ATTACHMENT 2

DETAILED ASSESSMENT

The site which is the subject of this Planning Proposal involves 3 Ellis Street, Chatswood.

Figure 1 - Extended CBD boundary

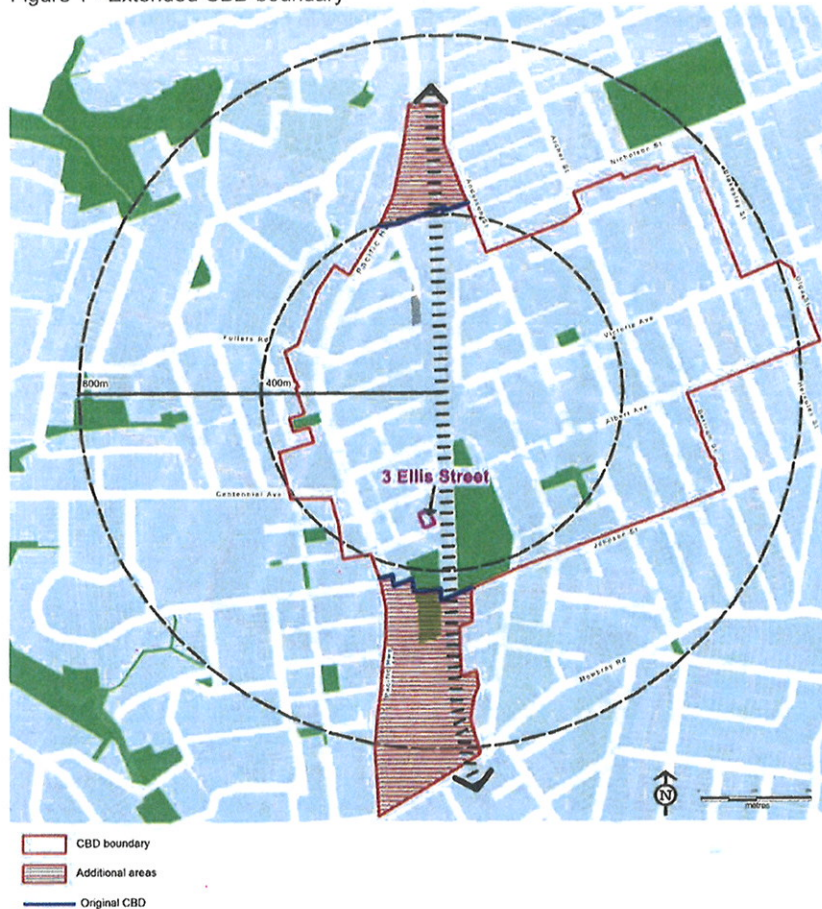
The subject site is located within the existing and the expanded Chatswood CBD boundary proposed in the CBD Strategy, as shown below in Figure 1.

Figure 2 – Land use

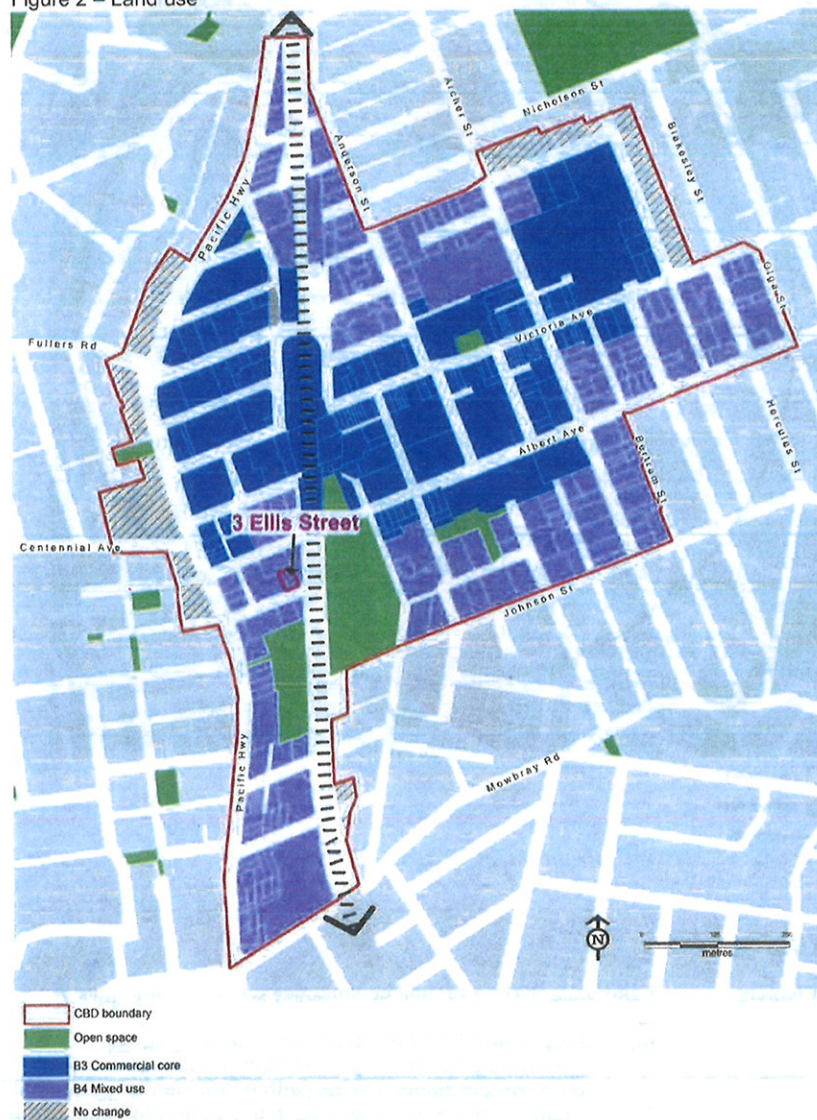
The subject site is located in that part of the Chatswood CBD identified as Mixed Use, meaning part commercial and part residential. Refer below to Figure 2 – Land use.

The proponent has proposed the zoning for the site be changed from R4 High Density Residential to B4 Mixed Use which is consistent with the CBD Strategy.

Figure 3 – Existing FSR under WLEP 2012

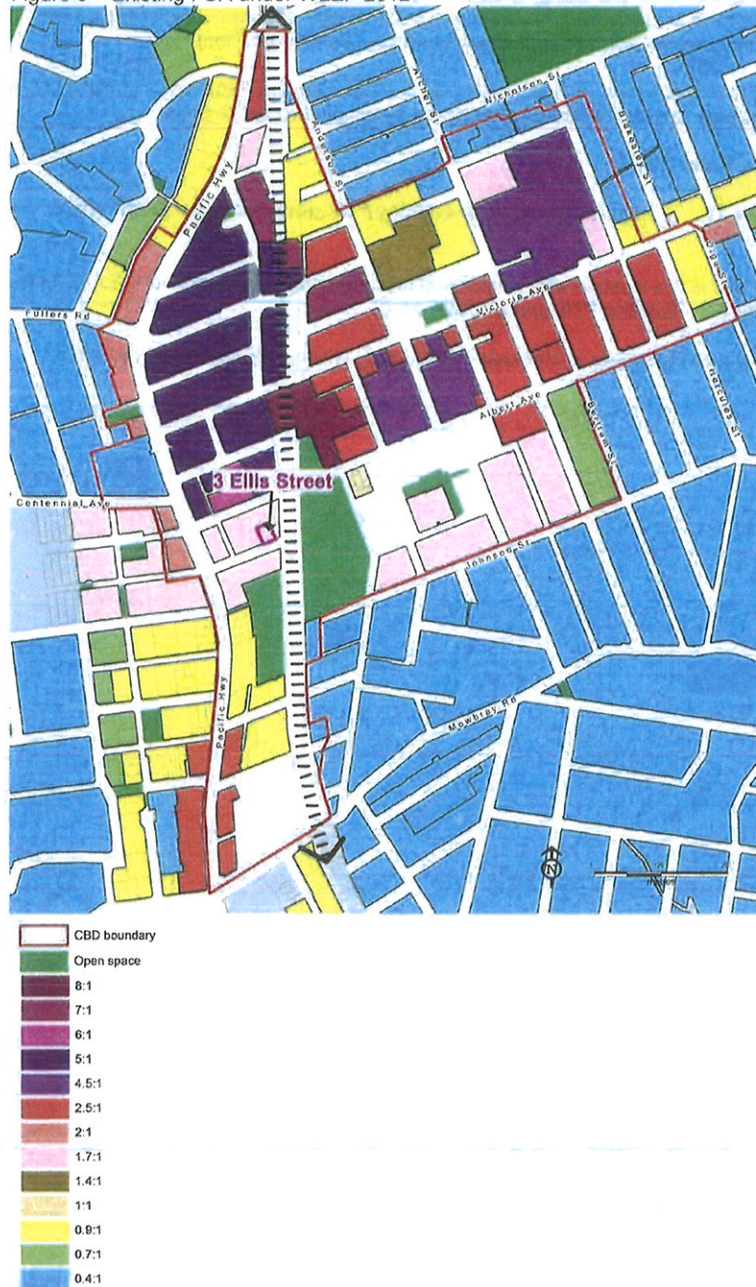
The subject site is in a location with an existing maximum floor space ratio of 1.7:1 as shown below in Figure 3 – Existing FSR under WLEP 2012.

The Planning proposal seeks to increase this to 4.5:1, which is discussed below in Key Element 12.

Figure 4 - Maximum Floor Space Ratio

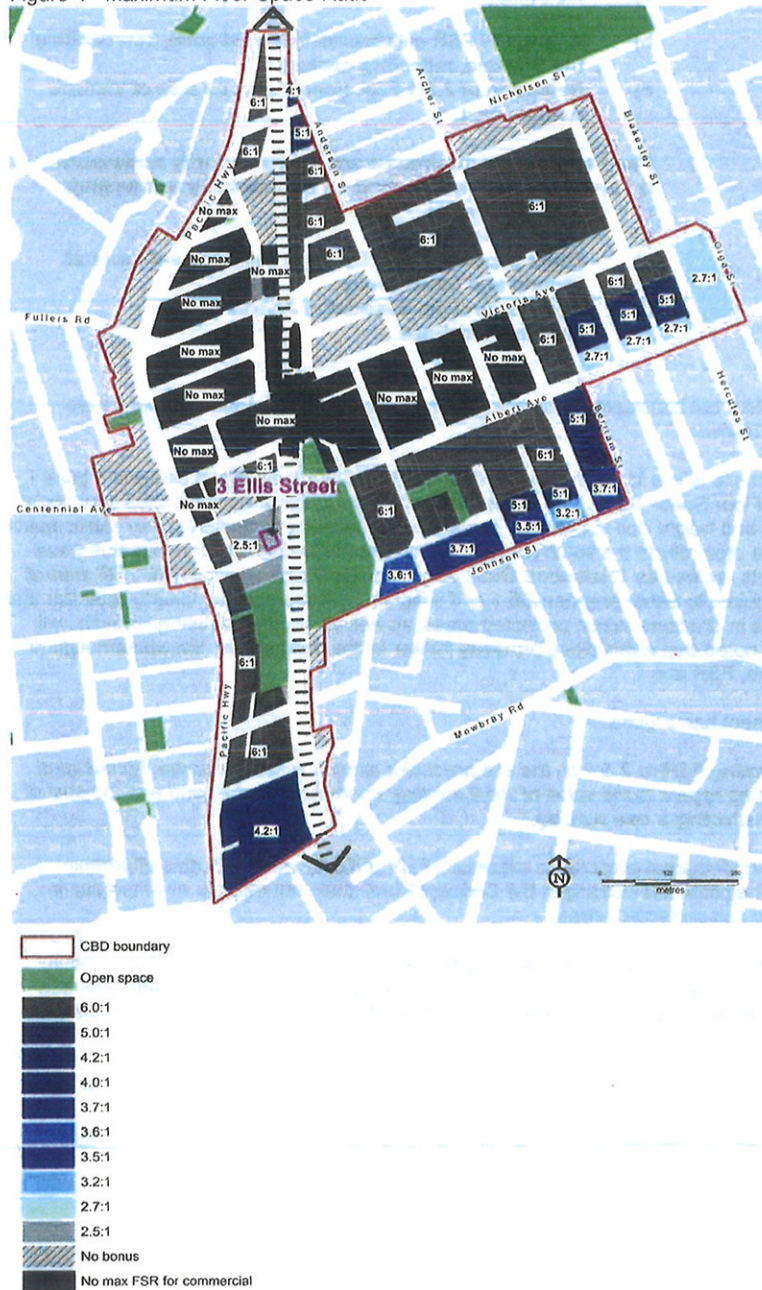
The subject site is in a location with a proposed FSR of 2.5:1, as shown below in Figure 4 - Maximum Floor Space Ratio. The site is located in a particular area of the CBD that has a lower FSR and height due to potential impacts on sun access protection to key public space within close proximity to the south (being the Chatswood Croquet Club greens and grass tennis courts, as well as Chatswood Oval). Any Planning Proposal within this FSR area of 2.5:1 is required to either propose 2.5:1 or if a higher FSR is proposed, clearly establish that no increase in shadows to sun protected areas, as well as no other adverse impacts, will occur. It is noted that within close proximity further to the north and on the western side of Crispe Lane, FSR is 6:1.

The Planning Proposal proposes a maximum FSR of 4.5:1, which includes affordable housing. The proposed building in the Concept Plans does not result in any increase in shadows to sun protected areas.

On the basis of no increase in shadows to sun protected areas, and acceptable amenity impacts to neighbouring properties and the public domain, it is considered reasonable to consider the Planning Proposal, and the requested FSR, in the circumstances of this case.

Figure 5 - Sun Access Protection for Public Spaces

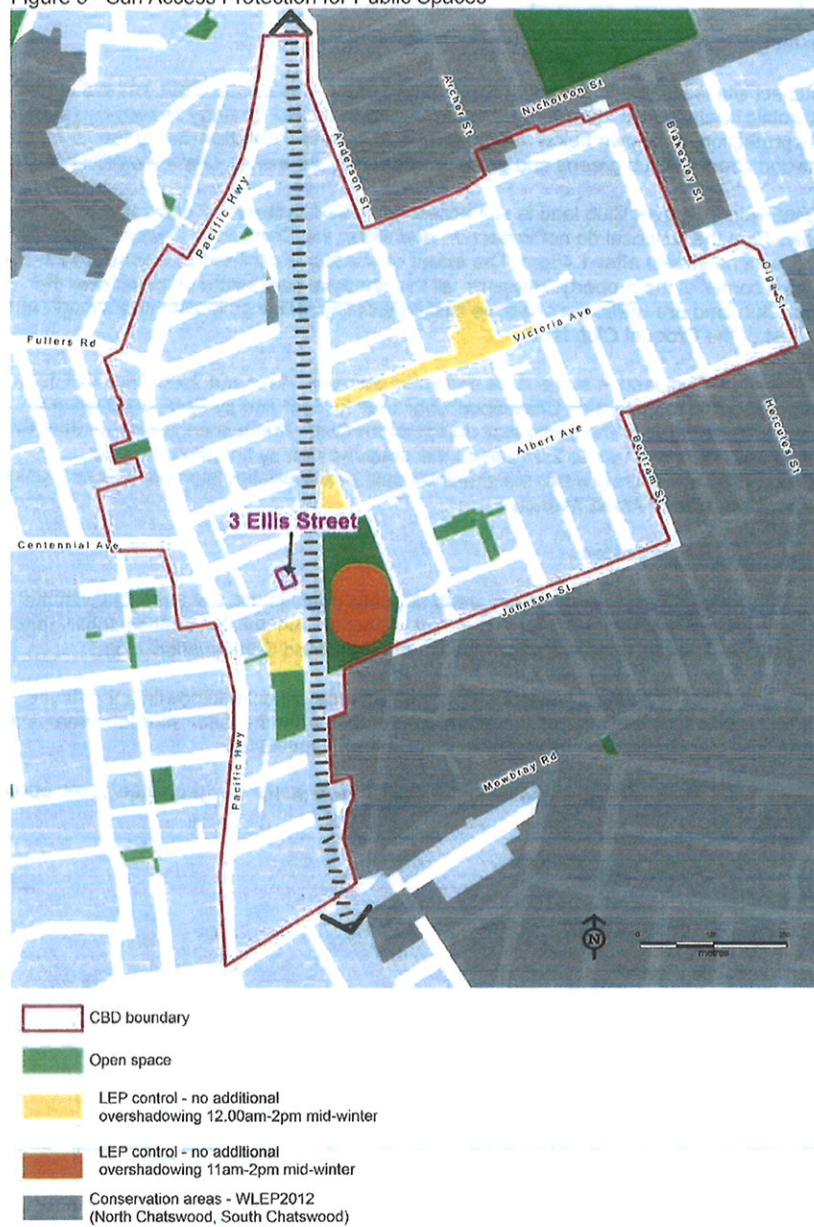
The subject site is located in the south western part of the Chatswood CBD, just to the north of key public open spaces identified within the Chatswood CBD Strategy as requiring sun access protection, as shown below in Figure 5 - Sun Access Protection (being the Chatswood Croquet Club greens and grass tennis courts, as well as Chatswood Oval).

As noted above, there is no increase in mid-winter shadow to the sun protected public open space areas.

Figure 6 – Height

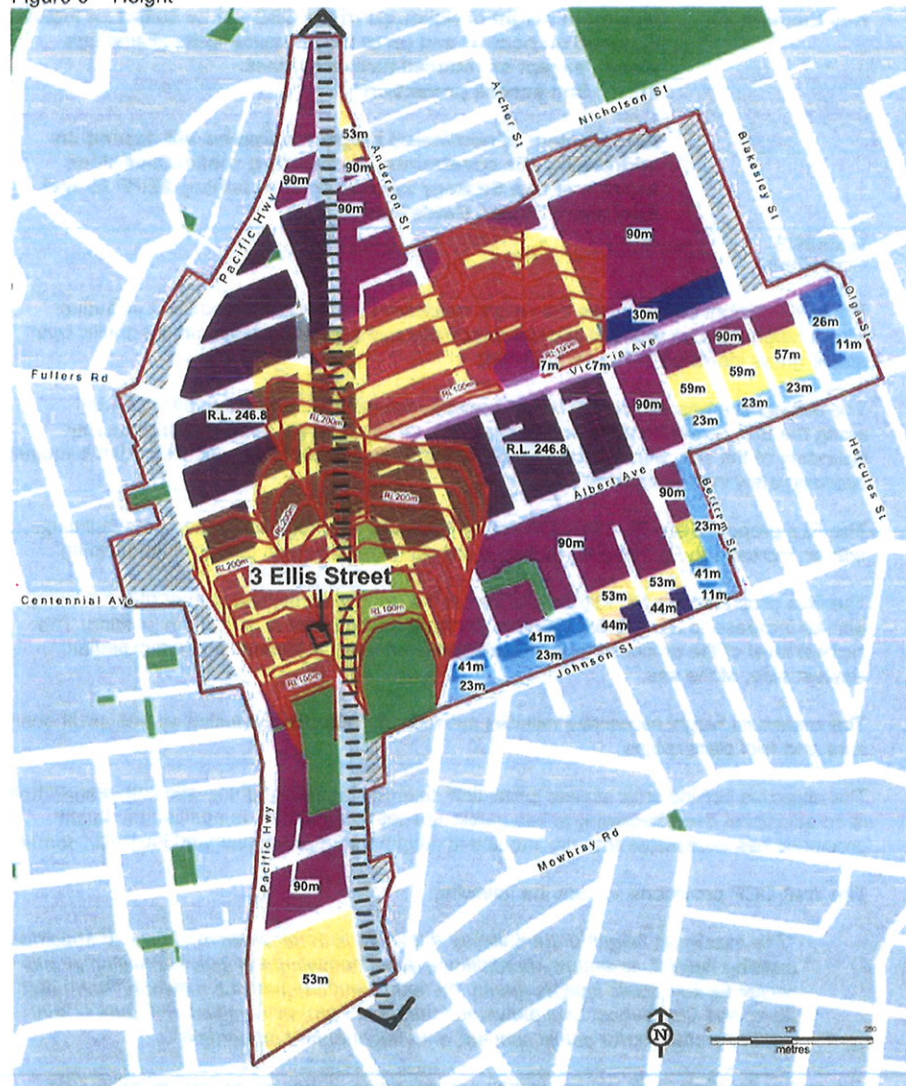
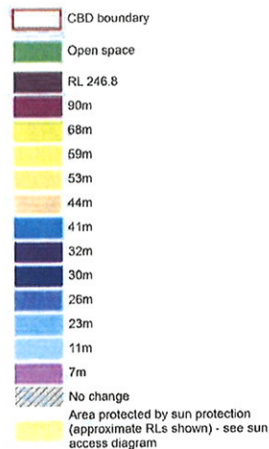
Figure 6 – Height below shows the height maximums in the Chatswood CBD, including where height is to be reduced in order to achieve sun access protection to the public open space areas identified in Figure 5 (above).

The height proposed of 44m subject solar access protection is satisfactory, having regard to the draft DCP provisions accompanying this Planning Proposal. In addition, prior to any public exhibition, concept plans are required to be provided that clearly show that at no point

the proposed mixed use building encroaches on the sun access protection plane determining height on this site.

Figure 7 - Links and New Open Space

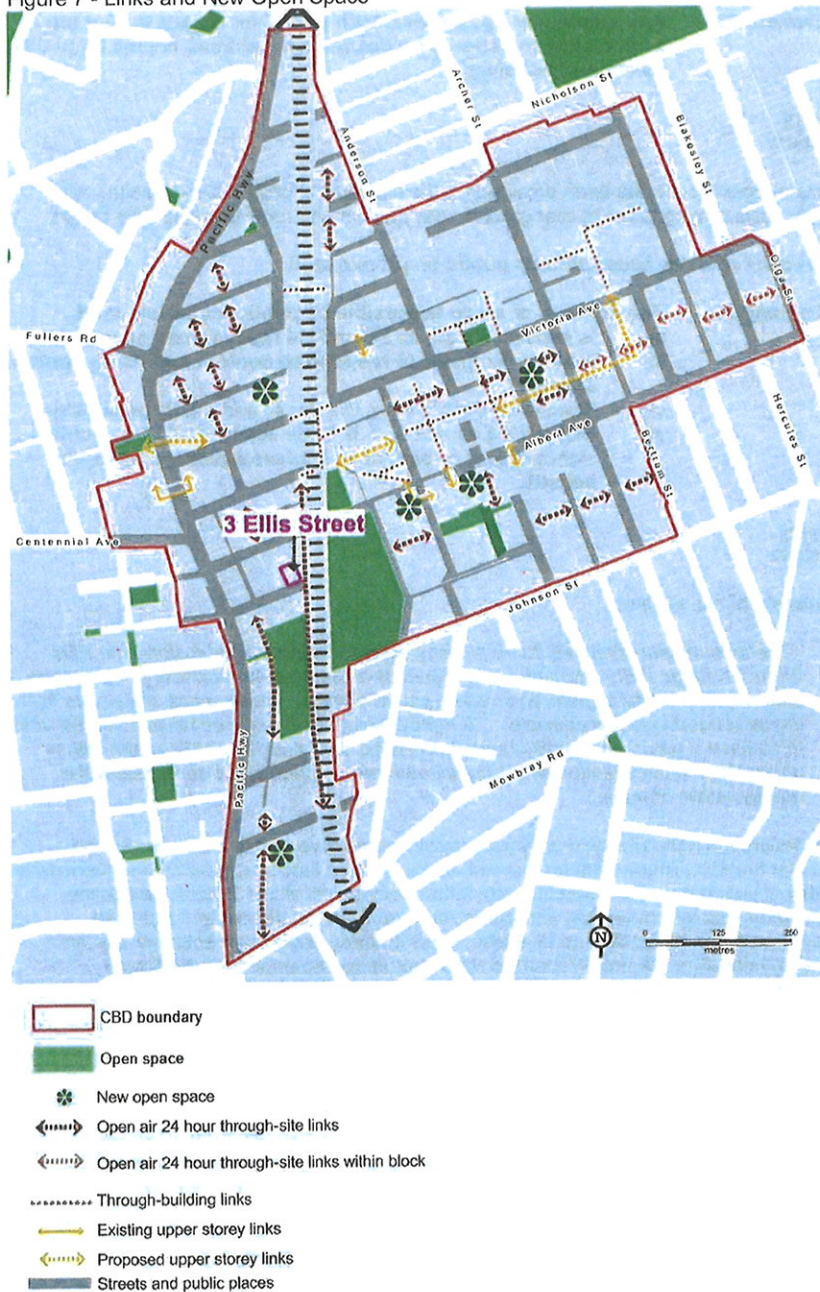
The subject land is not identified in Figure 7 of the CBD Strategy. It is also noted the site is located close to Frank Channon Walk, which includes a cycleway.

This public access over the site, contributing to the provision of a future new mid block pedestrian link, and the future widened access to the Frank Channon Walk, is considered consistent with the objective of improved access in the Chatswood CBD and is an important reason behind Council supporting this Planning Proposal.

"A public right of way is to be provided on the 3m setback along the western boundary, and the 2m Ellis's frontage."

Figure 8 - Setbacks and street frontage heights

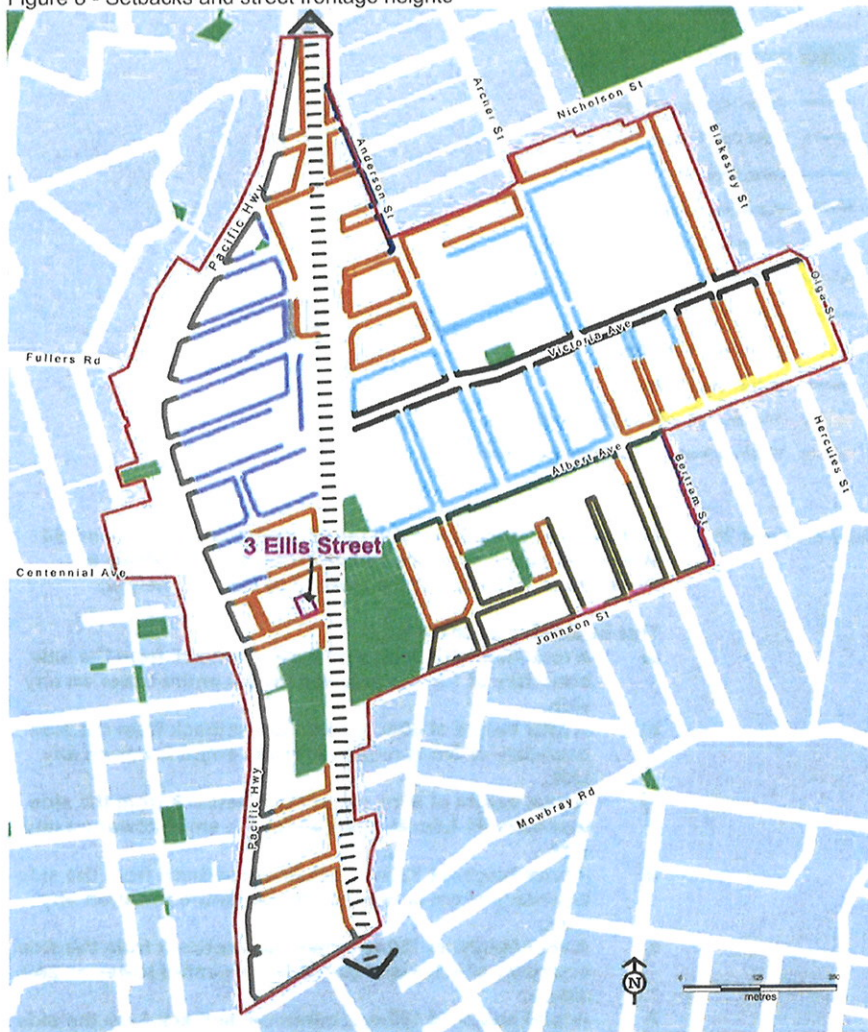
The concept plans are consistent with the below Figure 8 requirements applying to the subject site.

Ground level setbacks greater than the requirements in the Mixed Use frontage with Commercial Ground Floor Precinct have been provided and are encouraged on this site. Ground level setbacks greater than the requirements in the Mixed Use frontage with Commercial Ground Floor Precinct have been provided and are encouraged on this site. It is noted that in accordance with setbacks of 3m or more, deep soil planting has been provided. This has created a greater setback to the boundary with the existing residential flat building at 7-13 Ellis Street, the potential for a new pedestrian link, the opportunity for ground level landscaping and the minimizing of any impacts of the two large trees within the 7-13 Ellis Street site (along the boundary).

Podium street wall height is 7.6m facing Ellis Street, well below the 14m maximum.
